# Mobile Intel® Celeron® Processor on .13 Micron Process in Micro-FCPGA Package

Specification Update

*June 2004*

Document Number: 251309-021

**Figure 2. System Bus Reset and Configuration Timings**

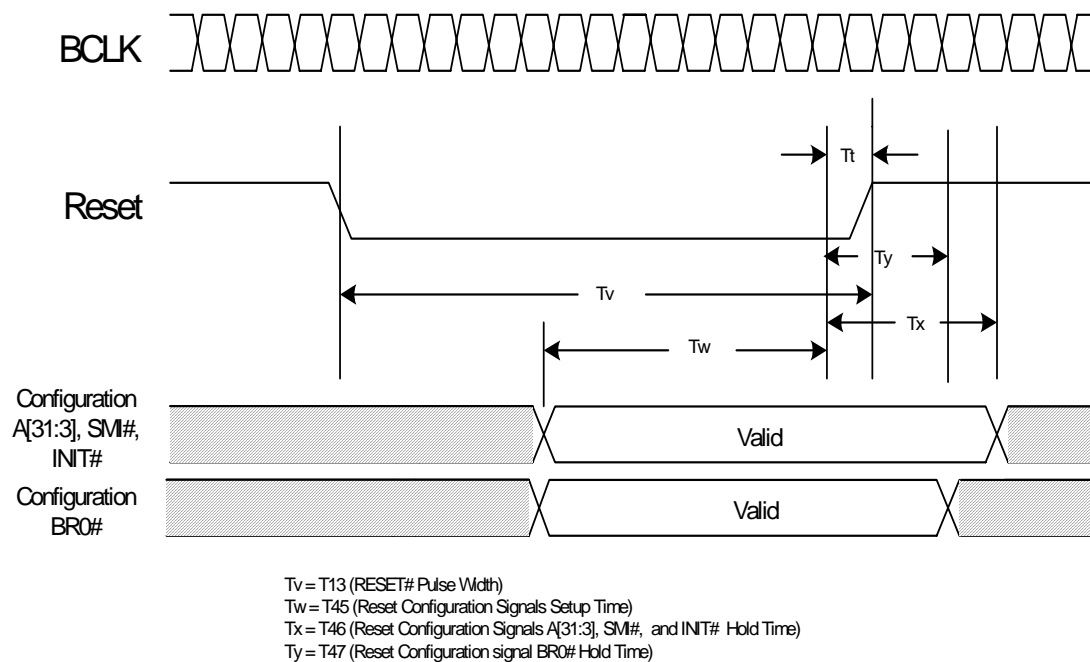
## V2. BR0# Maximum Hold Time Specification Change

The BR0# maximum hold time has changed to 2 BCLKs. This change will be shown in the “System Bus AC Specifications (Reset Conditions)” table and “System Bus Reset and Configuration Timings” figure of the *Mobile Intel® Celeron® Processor on .13 Micron Process in Micro-FCPGA Package Datasheet*. This change will be incorporated in the next revision of the datasheet.

The following figure will be modified to reflect this change

T# Parameter	Min	Max	Unit	Figure	Notes
T45: Reset Configuration Signals (A[31:3]#, BR0# INIT#, SMI#) Setup Time	4		BCLKs	13	1
T46: Reset Configuration Signals (A[31:3]#, INIT#, SMI#) Hold Time	2	20	BCLKs	13	2
T47: Reset Configuration Signal BR0# Hold Time	2	2	BCLKs	13	2
